NATIONAL AERONAUTICS AND SPACE ADMINISTRATION (TEST REACTOR)

DOCKET NO. 50-30

AMENDMENT TO FACILITY LICENSE

Amendment No. 10  
Licensee No. TR-3

**FIGURE 1**

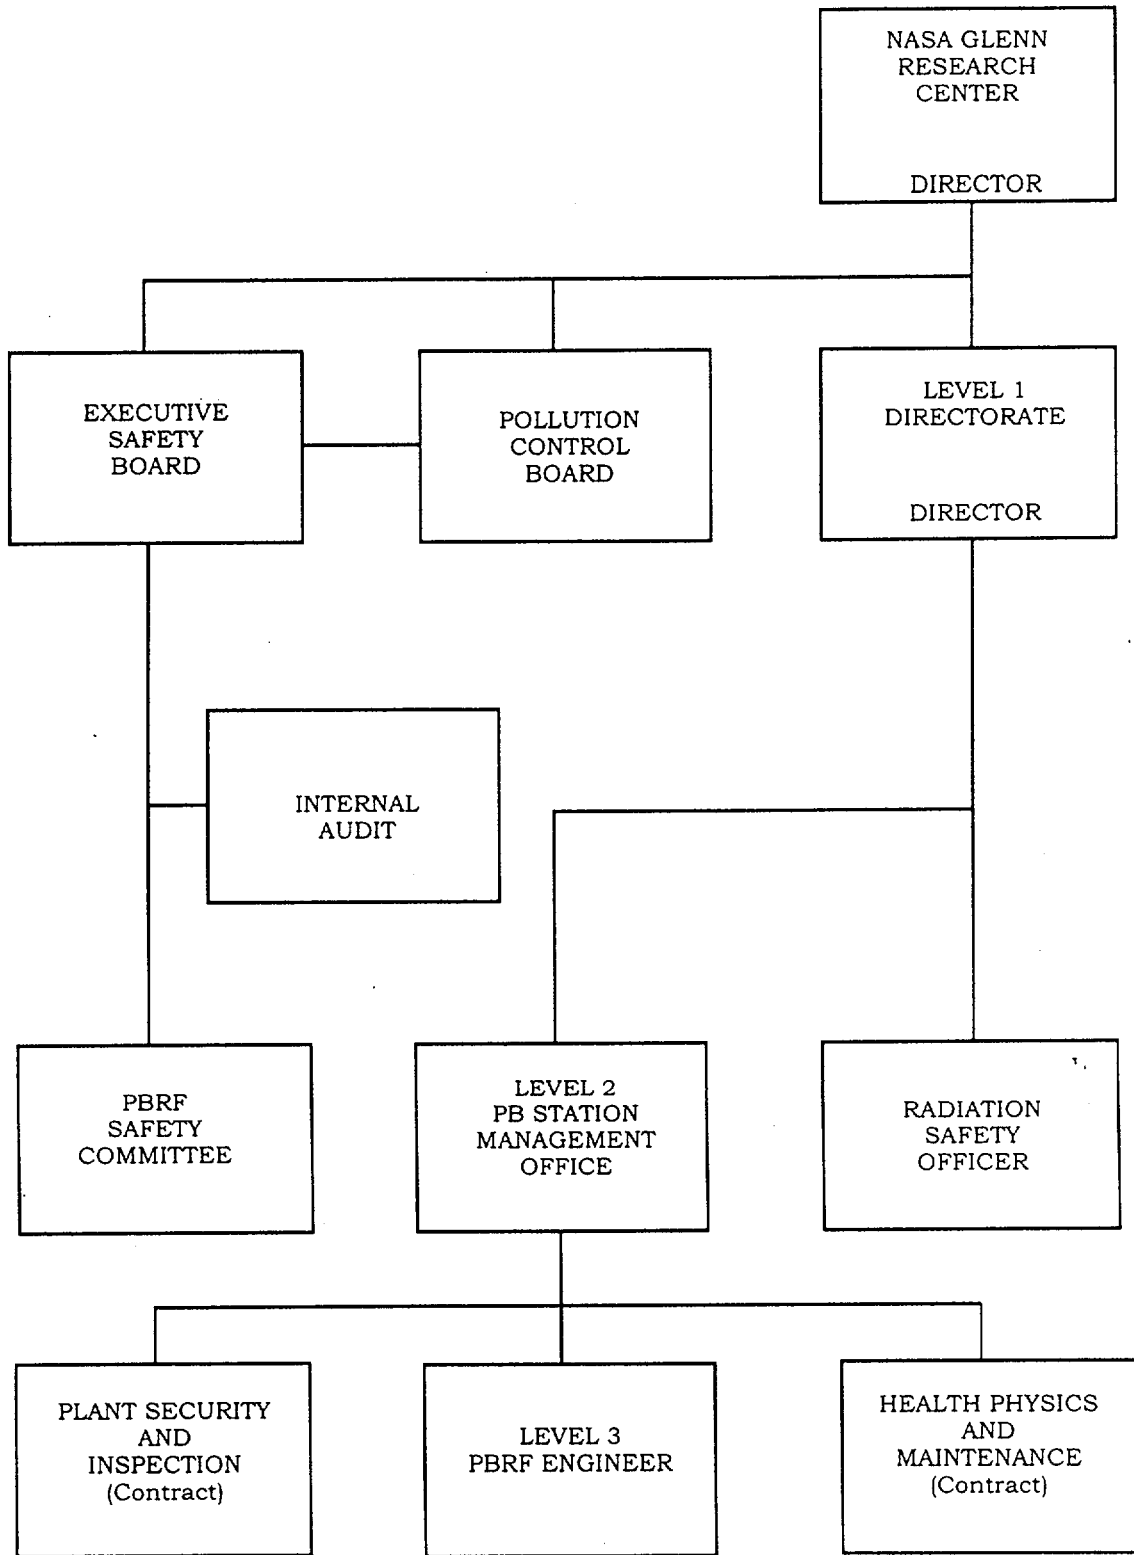
Replace the following pages of the Appendix A Technical Specification with the enclosed pages. The revised pages are identified by amendment number and contain vertical lines indicating the areas of changes.

21  
Figure 1
